Significant Concerns: AHRI/ANSI Standard 1230 Performance Rating of Variable Refrigerant Flow (VRF) Multi-Split Air-Conditioning and Heat Pump Equipment

Executive Summary

The Hydronics Industry Alliance – Commercial (HIA-C)¹ provides information in this white paper to identify areas of concern related to the existing, and proposed amended, provisions of AHRI/ANSI Standard 1230. This standard is currently in a negotiated revision process administered by the US Department of Energy.² It is the HIA-C's contention, supported by the information presented herein, that the test methodologies set forth in the current version of AHRI 1230 produce cooling energy efficiency ratings for VRF equipment which exceed actual operating efficiencies in the field by 25% to 60%, with an average of approximately 53% (see Appendix A). AHRI 1230 also produces heating energy efficiency ratings for VRF equipment which exceed actual operating efficiencies in the field by 30% to 60%, with an average of approximately 48% (Appendix H).

Appendix A – Real-World Operating Data for VRF Systems

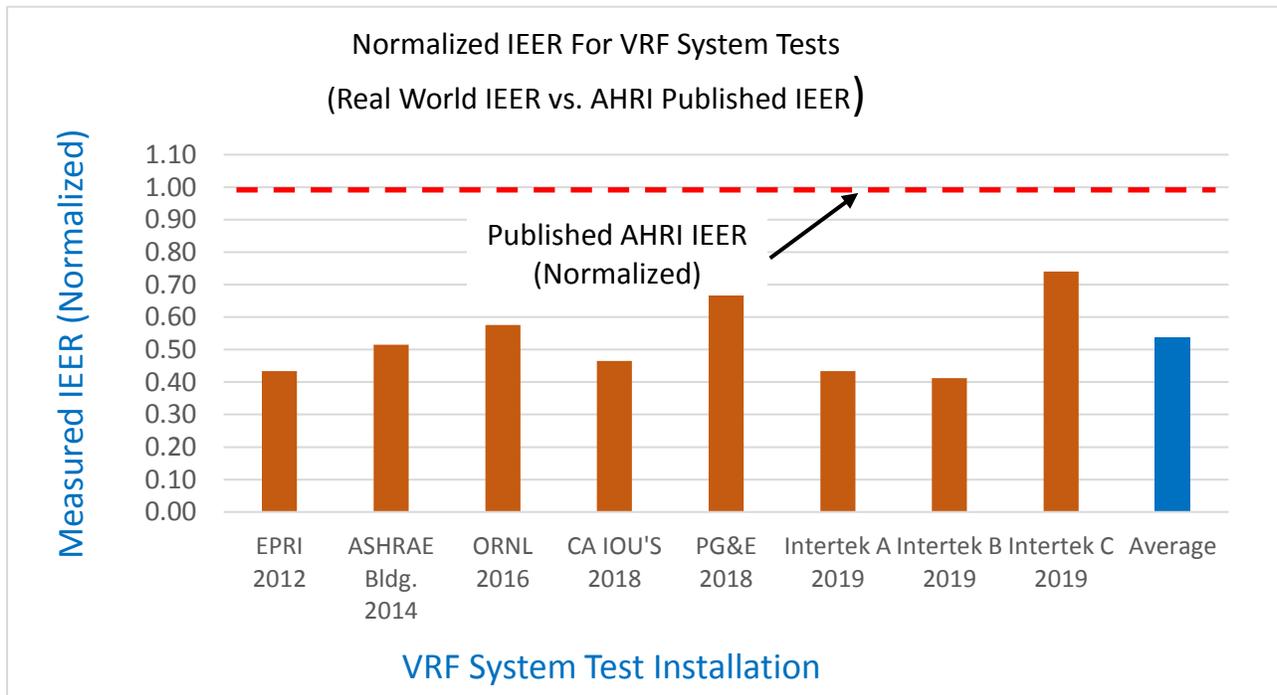
This is a critical area of concern given that ratings derived from the Standard 1230 test methodology are used by building owners, architects, electric utility energy efficiency program administrators, and HVAC design professionals to select amongst various HVAC system types. Currently there are no reliable data sources other than the AHRI ratings available to these key interest groups to assess equipment efficiencies. As a result, the AHRI ratings are used to compare efficiencies of various *systems* based on the rated IEER of various *equipment*, despite the original intent of AHRI to level the playing field between *different manufacturers of the same equipment*. This was not the original intention, however it is now the norm.

Appendix H – Real-World Operating Data for VRF Systems

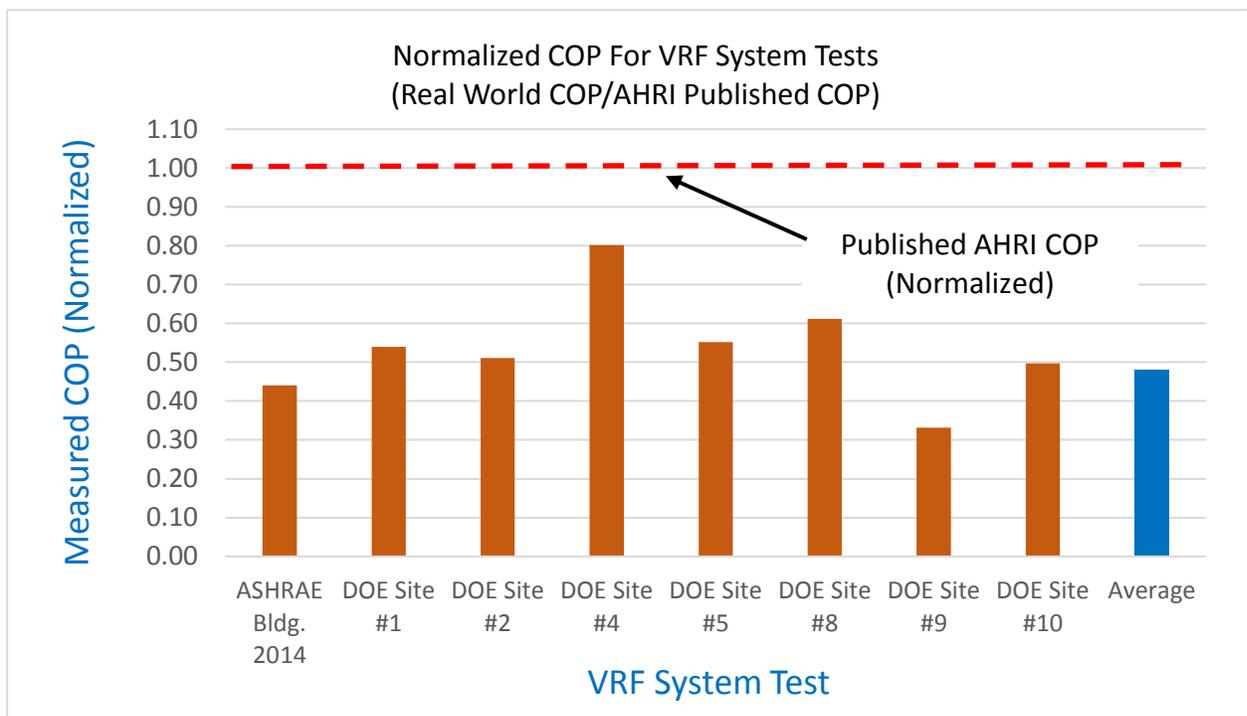
It is the HIA-C's contention, supported by the information presented herein, that the test methodologies set forth in the current version of AHRI 1230 produce heating energy efficiency ratings for VRF equipment which exceed actual operating efficiencies in the field by 30% to 60%, with an average of approximately 48% (Appendix H).

Appendix I – Hyper Heat Operation

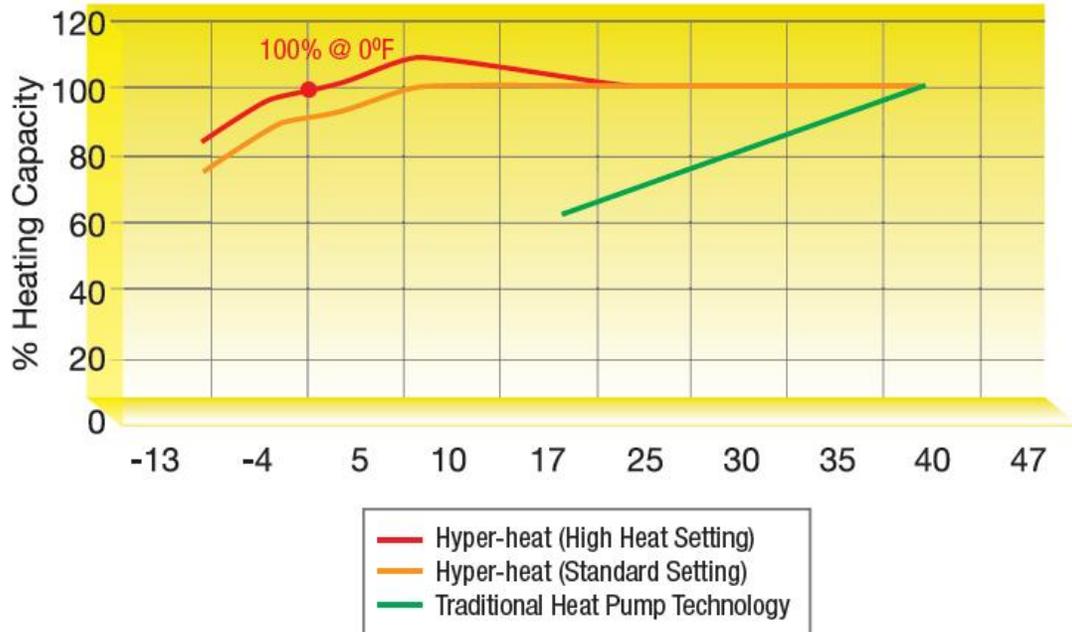
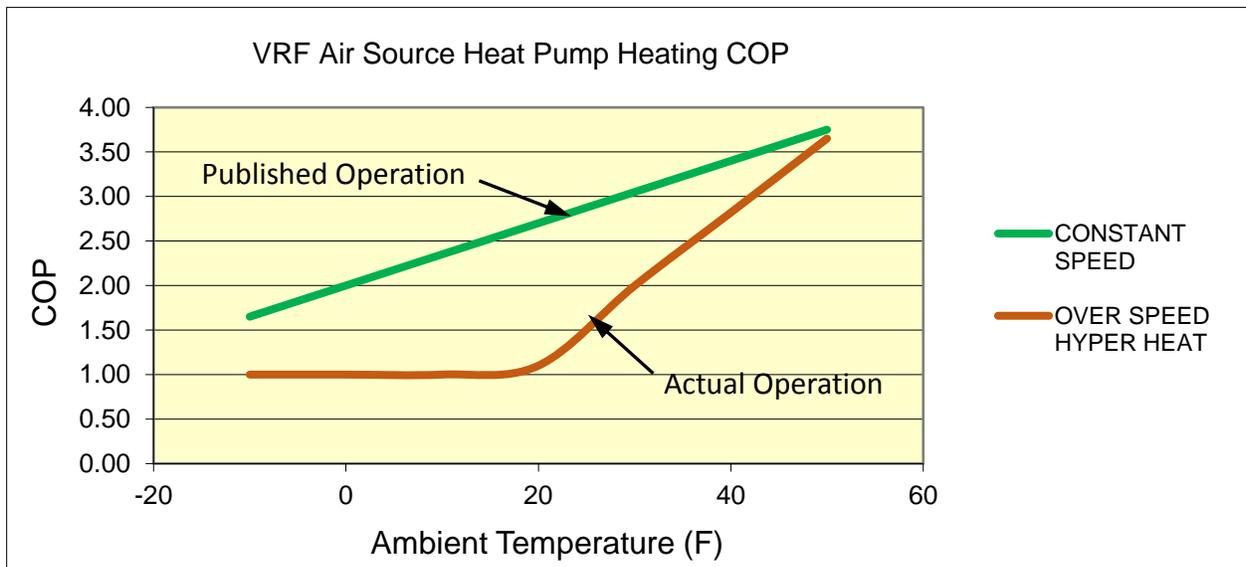
To compensate for this drop in capacity the variable speed compressor is speeded up to increase the mass flow rate and the heat transfer or heating capacity. This enables a Hyper Heat over speed unit to produce a constant capacity as the outdoor temperature drops. At approximately 10F to 15F the Hyper Heat unit reaches its' maximum over speed of approximately 50% and then remains at this speed. As the outdoor temperature drops the capacity then drops proportionately to what it would have been for a constant speed compressor (Appendix I).

However, this increase in capacity at lower outdoor air temperatures is not free and comes at a cost of reduced efficiency. The First Law of Thermodynamics is still the First Law, you can't get something for nothing. The COP of a constant speed heat pump at 47F is approximately 3.5 vs. 3.2 for the variable speed heat pump, not a large difference. However, at 17F this difference is 2.6 vs 1.1 an almost 60% difference. In addition, a COP of 1.1 is almost straight electric heat.

1230 currently does not require the testing and publication of hyper-heat or over speed capacities or COP's.

HIA-C's recommendation is to require the listing and certification of both the constant and hyper-heat or over speed heating capacities and COP's at 47F and 17F as well as low temperature operation of -25F.
